Environmental Review Team Report

Emerson's Laundromat
Old Lyme, Connecticut

Environmental Review Team
Report
on
Emerson's Laundromat
Old Lyme, Connecticut

November 1981

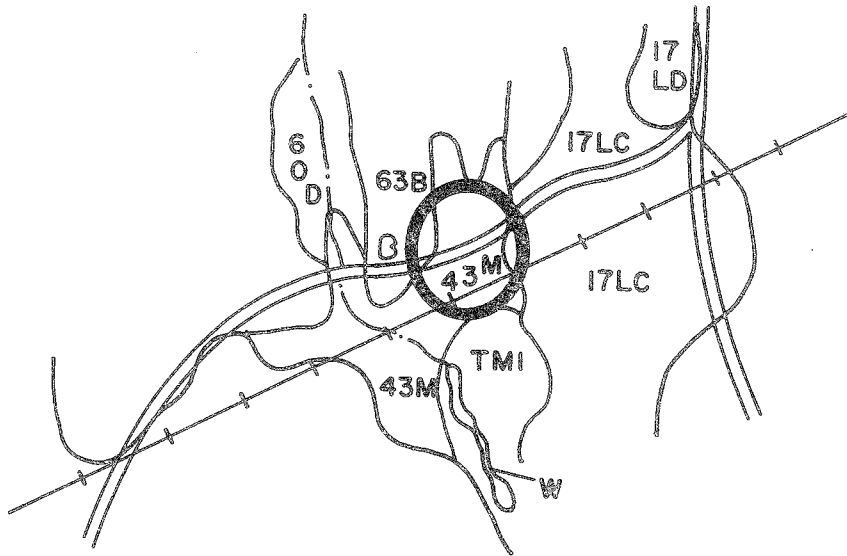
In general, the State Department of Health would have more concern with the possible contamination, or adverse chemical effect on the underlying aquifer which supports the laundromat's shallow well (reported to be about 20 feet deep). This well would continue to be utilized although it would be located only 75 feet east

of the nearest rows of leaching galleries. A separating distance of 75 feet is considered to be the minimum distance for low yield wells (less than 10 gpm). Generally, this would be the type of well serving a single family residence or business having a low water usage. In addition, the volume of sewage and/or type and volume of waste water being discharged in the vicinity of a well would also be a factor that should be taken into account. In this case the expected flow from the laundromat is approximately 5,000 gallons per day. However, based on the number of washing machines (fifteen, a few of which are triple loaders), hours of operation, and consideration of the peak influx of summer residences, it is conceivable the daily flow would increase during this period of the year. At the same time, there would be an increased demand put upon the well. While it would appear the discharge area(s) for the aquifer and leaching system is towards the drainage channel and the lower western (river) side of the property, natural seasonal drop in the water table, coupled with pumping more water from the well's recharge area, could cause changes in the elevation and slope of the water table.

Although the well in question would only be utilized for washing purposes (non-potable), there is the possibility it could introduce contaminants to the aquifer which would not be satisfactorily attenuated by filtration, biological or chemical means and dilution. For these reasons, a new well, which would be more remotely located from the leaching area, should be given serious consideration. In turn, the existing well should be abandoned in accordance with accepted practices. This would not only provide for greater protection of the water supply aquifer, but would probably allow for some flexibility in the placement of the leaching system components. In turn, increasing the separating distance between the galleries and drainage channel would provide further treatment and improvement of the waste effluent.
